PROJECT
STACK MANCHESTER

Project Title
Stack Manchester

Drawing Title
Fire Safety Strategy Comments

Document reference	Drawn	Reviewed	Date
1151_SK01.3	DG	AW	07/08/24

TITLE
PROPOSED FLOOR PLAN GROUND LEVEL

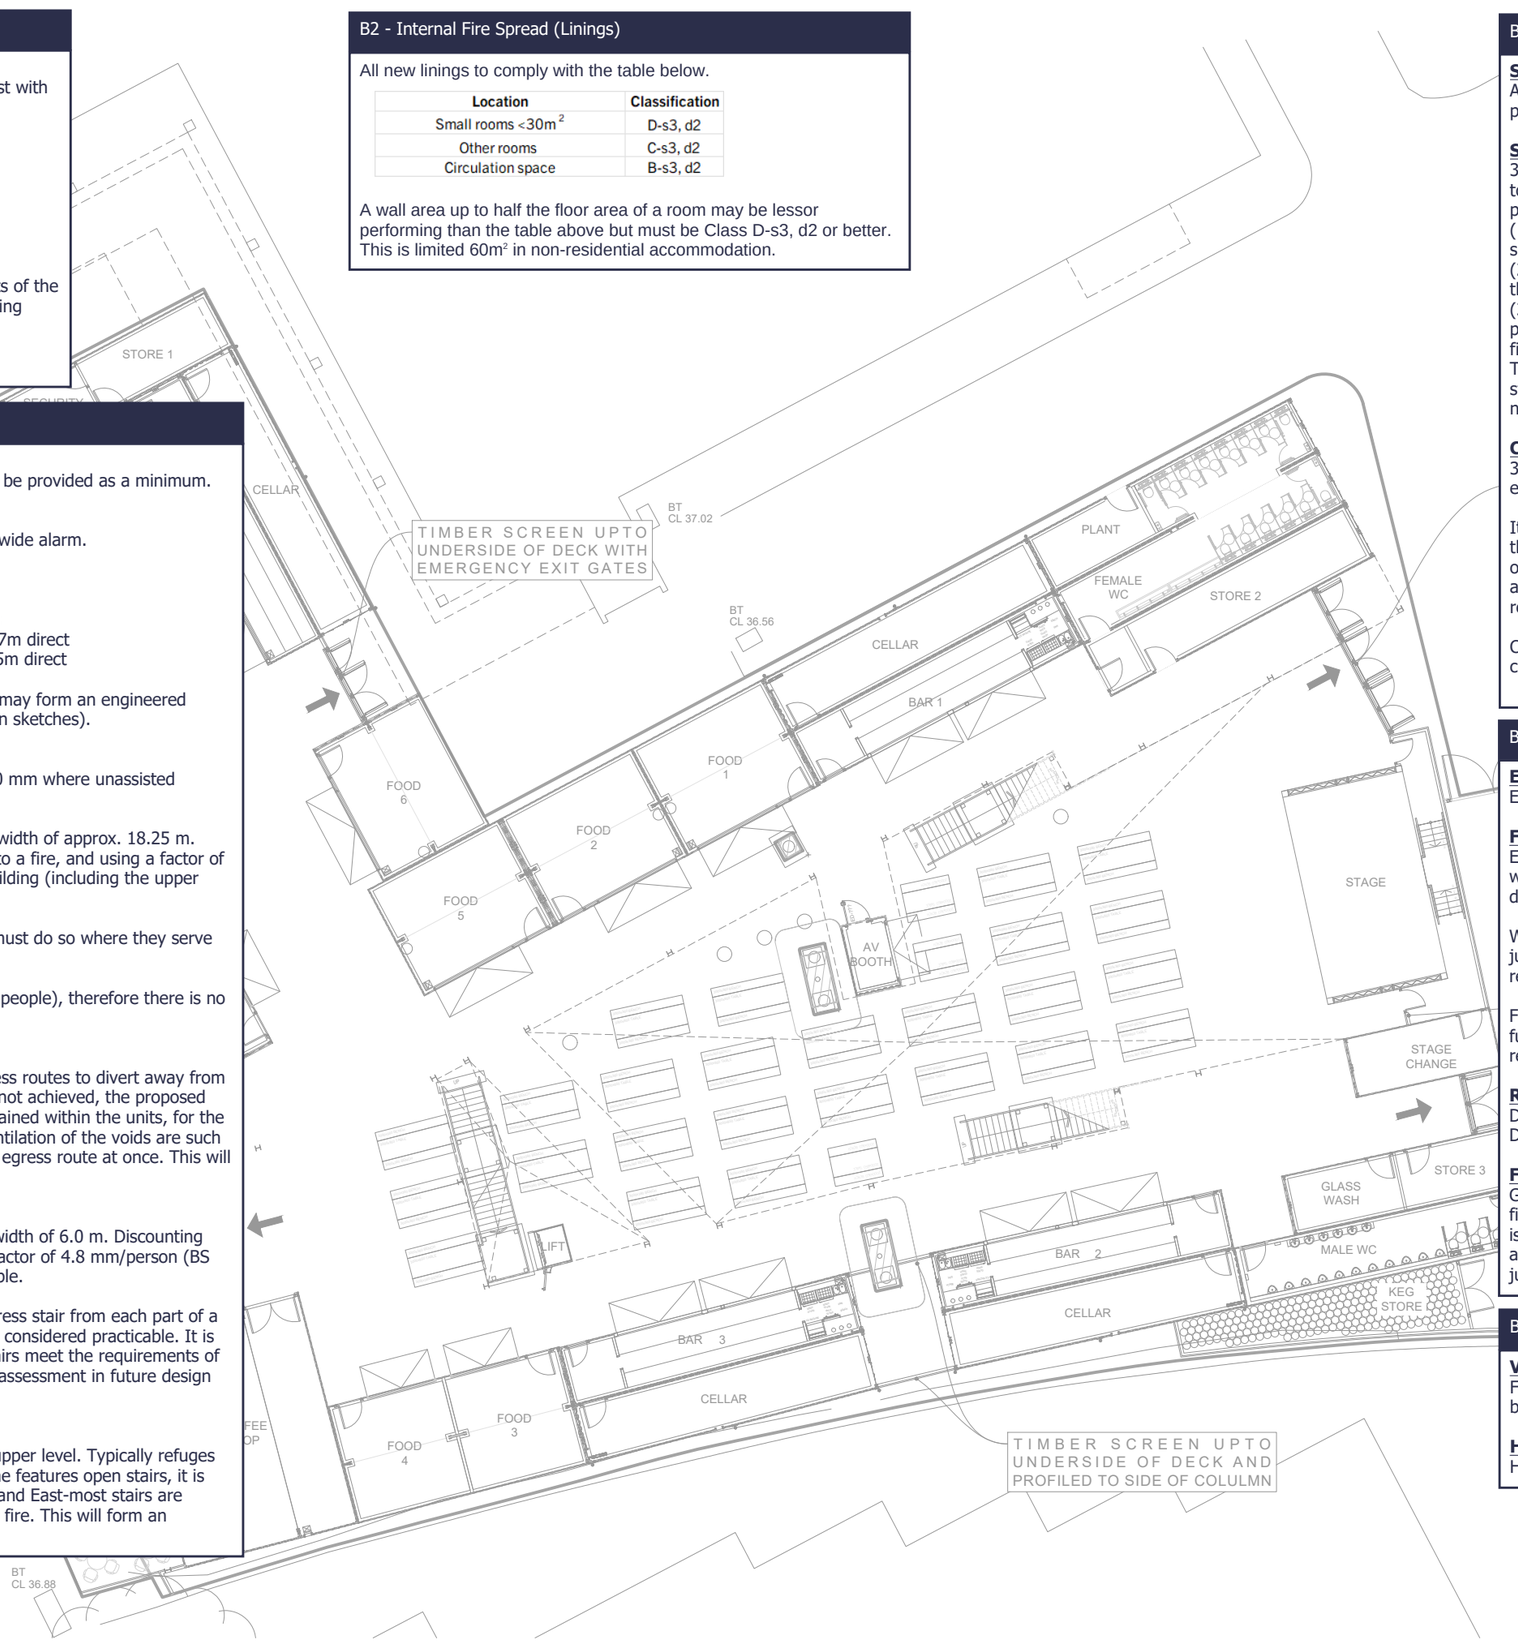
Travel distances are exceeded within the current design. This may form an engineered justification or require minor layout changes (see comments on sketches).

Escape past voids
Where voids are present, BS 9999 would typically require egress routes to divert away from voids, and not pass within 4.5 m of the opening. While this is not achieved, the proposed design is considered reasonable as the fire load is largely contained within the units, for the most part egress is available in two directions and the size/ventilation of the voids are such that it is unlikely that a single fire would affect more than one egress route at once. This will form an engineered justification in future design stages.

Vertical escape
The Upper level is served by 4 stairs providing a total egress width of 6.0 m. Discounting the largest stair which may be lost due to a fire, and using a factor of 4.8 mm/person (BS 9999), the maximum occupancy of the Upper level is 937 people.

BS 9999 would typically require a minimum of one internal egress stair from each part of a building. However, given the nature of the building, this is not considered practicable. It is therefore proposed to demonstrate that the open, external stairs meet the requirements of Part B of the Building Regulations. This will form a qualitative assessment in future design stages.

TITLE
PROPOSED FLOOR PLAN UPPER LEVEL

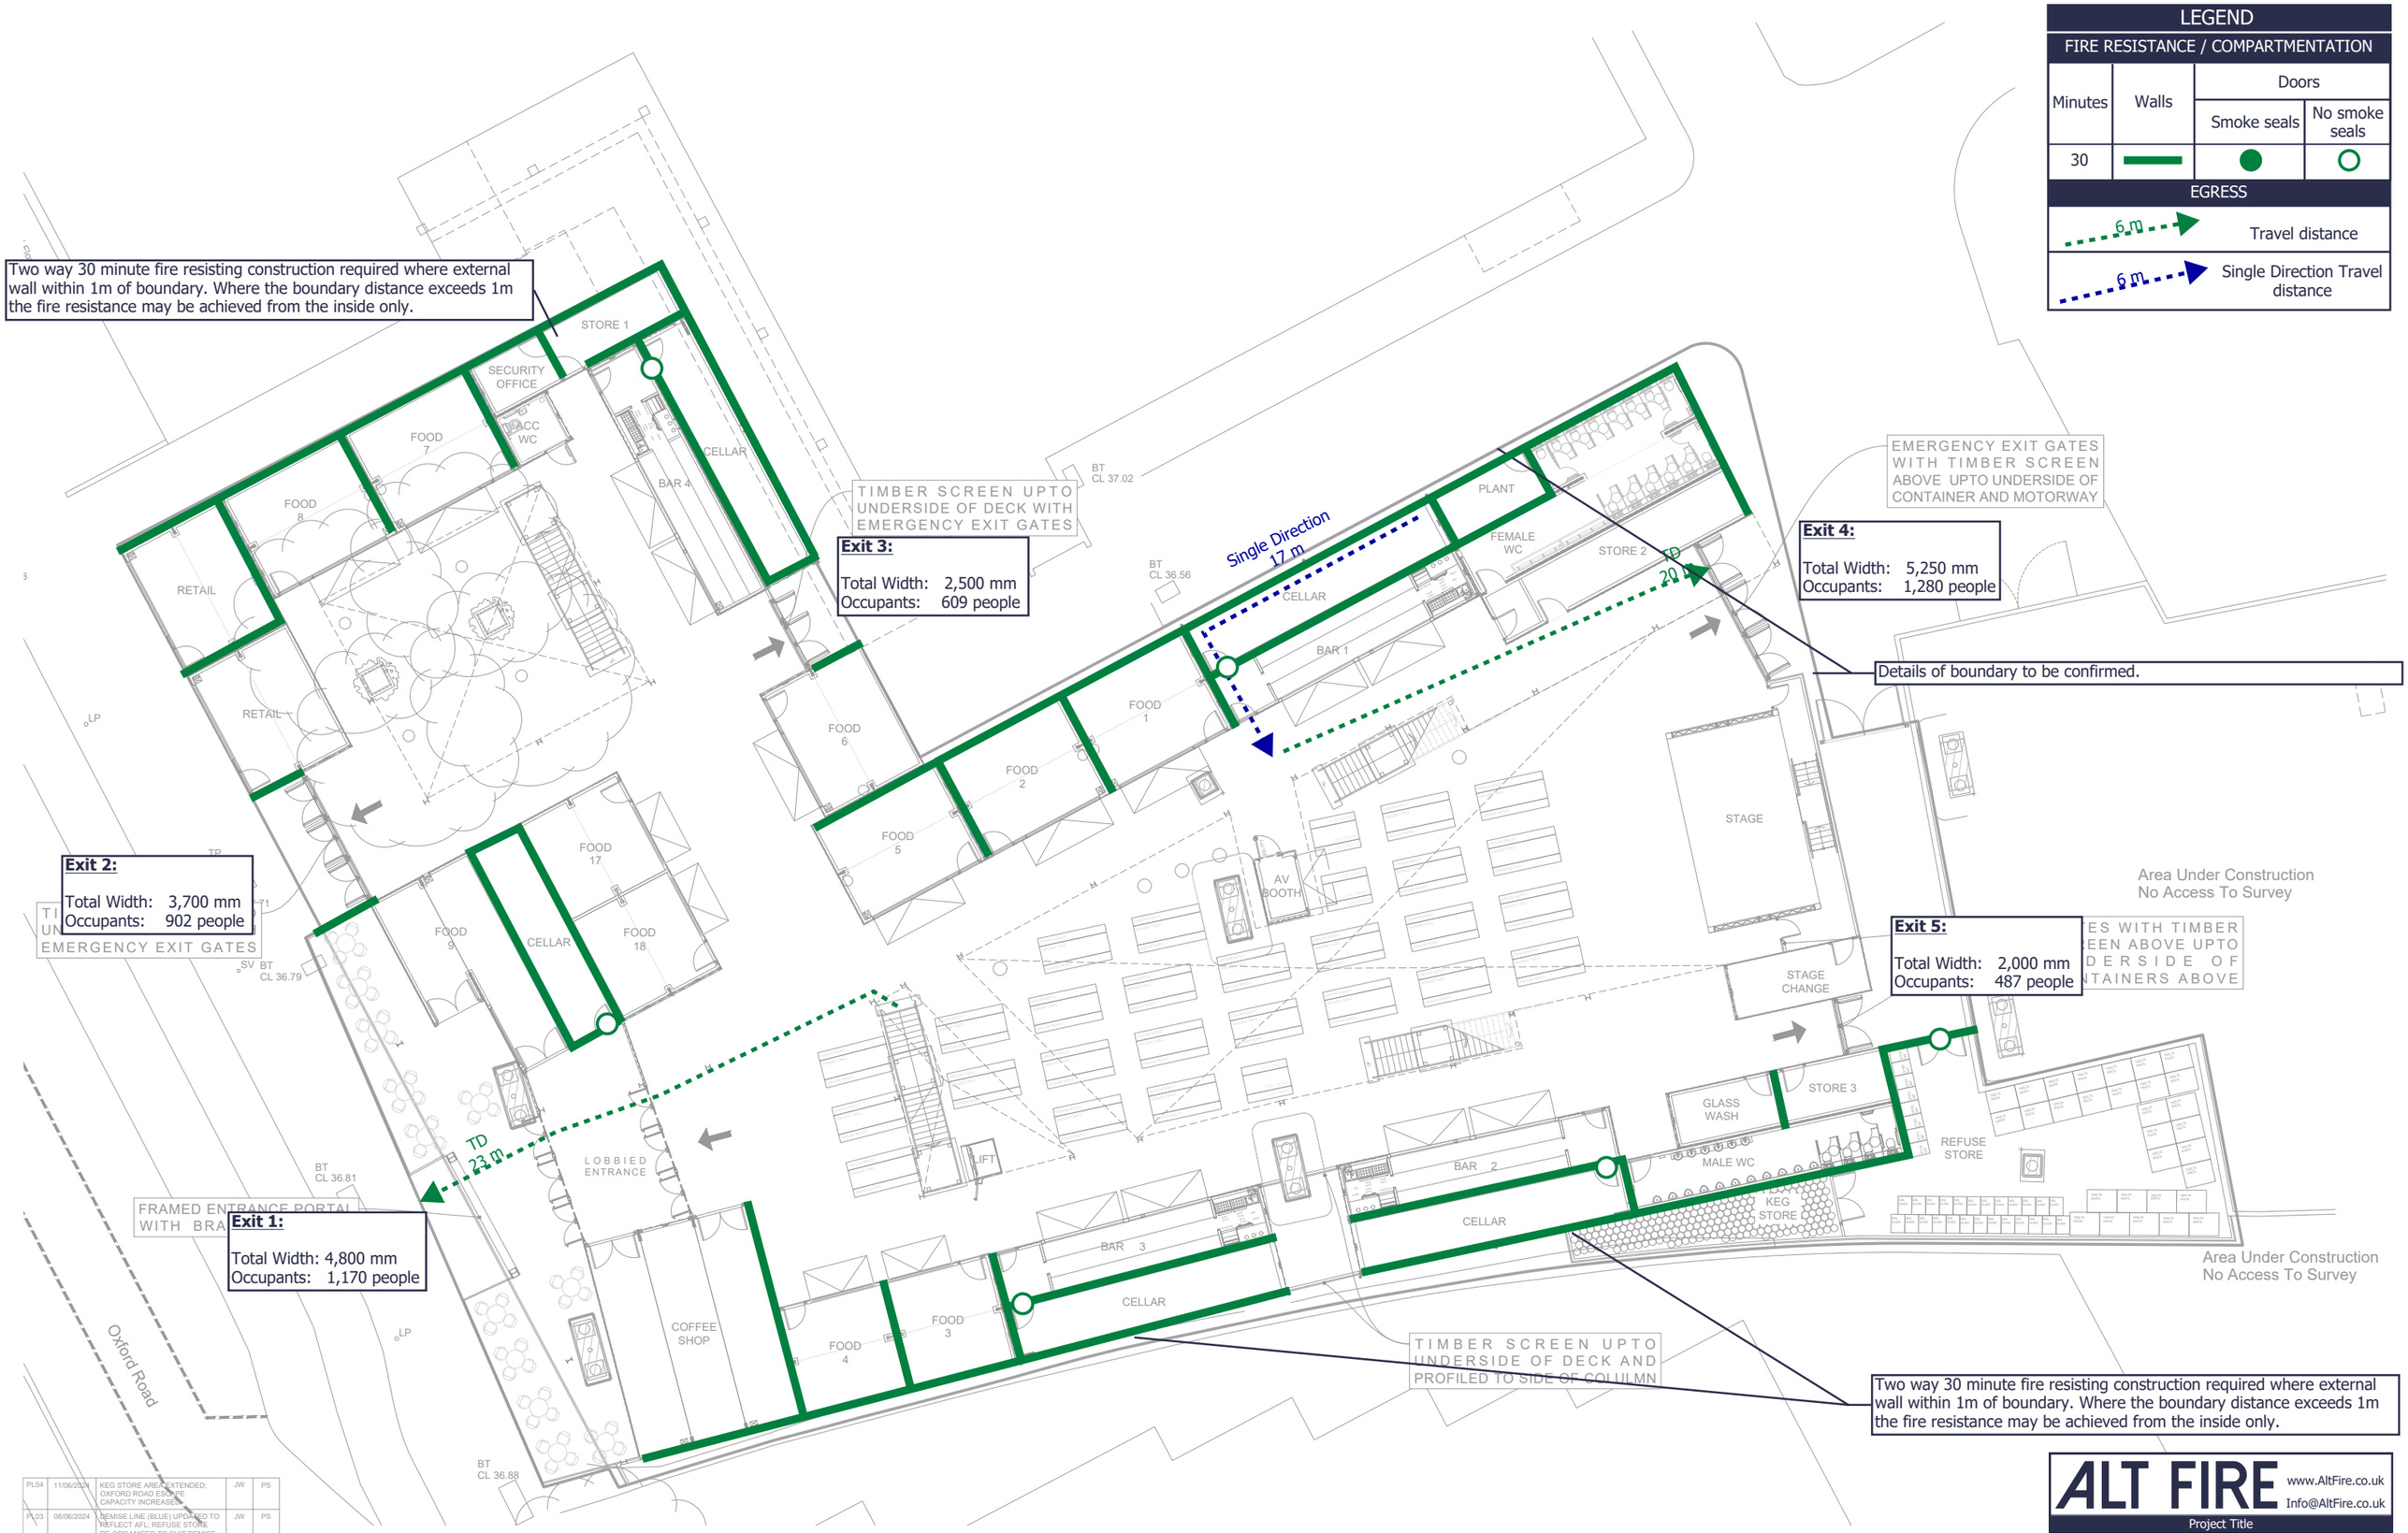
Typically a two way 30 minute fire rating is required where external walls are within 1m of boundary. However, given the fire load within the open-sided containers, an engineered justification may be provided to reduce the external fire spread requirements.

Typically BS 9999 would require disabled refuges to be located within a protected lobby/stair. As only open stairs are proposed, it will be necessary to demonstrate that a single fire will not affect the two refuges simultaneously. This will form an engineered justification in future design stages.

Reaction to fire properties of the fabric should comply with both the requirements of Part B2 (C-s3, d2) and B4 (B_{ROOF}t4). The product to be used should be confirmed.

BS 9999 would typically require egress routes not to pass within 4.5m of voids. Given the size of the voids, the distribution/location of the fire load and the ventilation of this space, this is considered overly onerous. This will form an engineered justification during later design stages.

Minor extension to travel distances, given the ventilation of the space it is suggested that this forms an engineering justification during later design stages.

Two way 30 minute fire rating required where external wall within 1m of boundary. Where the boundary distance exceeds 1m a percentage of the external wall will require a one way fire rating.

Two way 30 minute fire rating required where external wall within 1m of boundary. Where the boundary distance exceeds 1m a percentage of the external wall will require a one way fire rating.
